ADDENDUM I

SUBJECT: Annual Contract for First Responder Trucks for the Fire Department, (RFO #6100013655), Scheduled to Open: February 22, 2021 at 10:00 am; Date of Issue: February 8, 2021

THIS NOTICE SHALL SERVE AS ADDENDUM NO. I – TO THE ABOVE REFERENCED REQUEST FOR OFFER

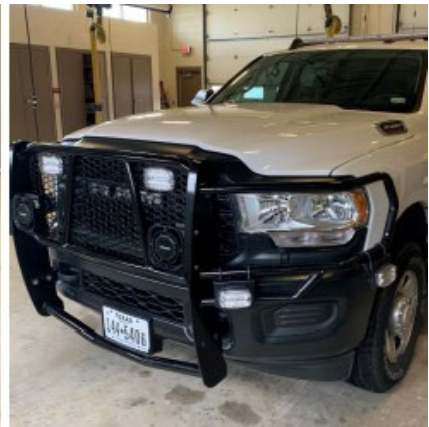
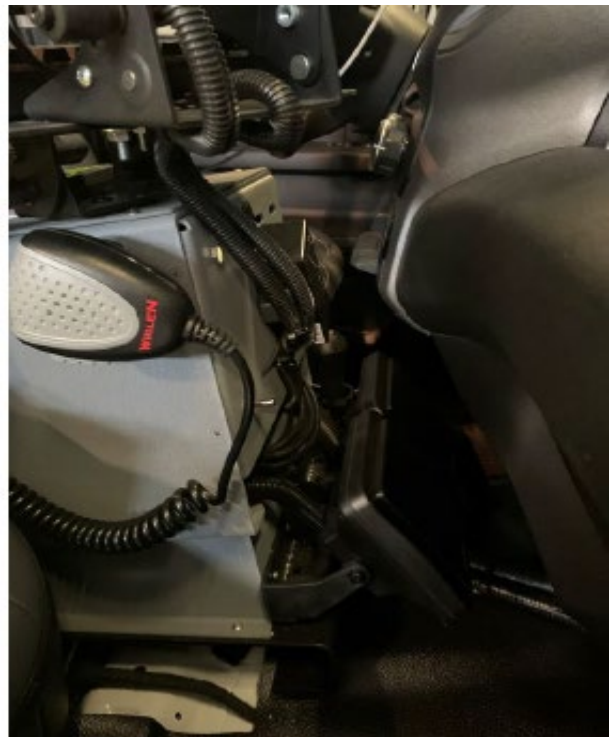
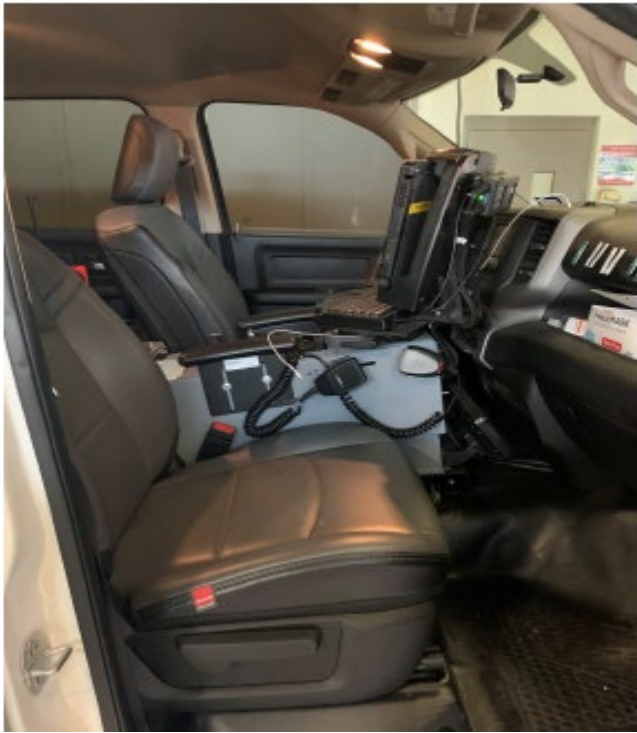
Question 10: Can photos of the vehicle be made available?

All vehicles will have similar roof layout, exact same console and grill design

All vehicles will have same battery box design

Bid Item 1:

Bid Item 2 & 3:

Item 2 and 3 are similar just different chassis

Item 2 and 3 are similar just different chassis and no slide out in item 3.

Response: Yes, please see below.
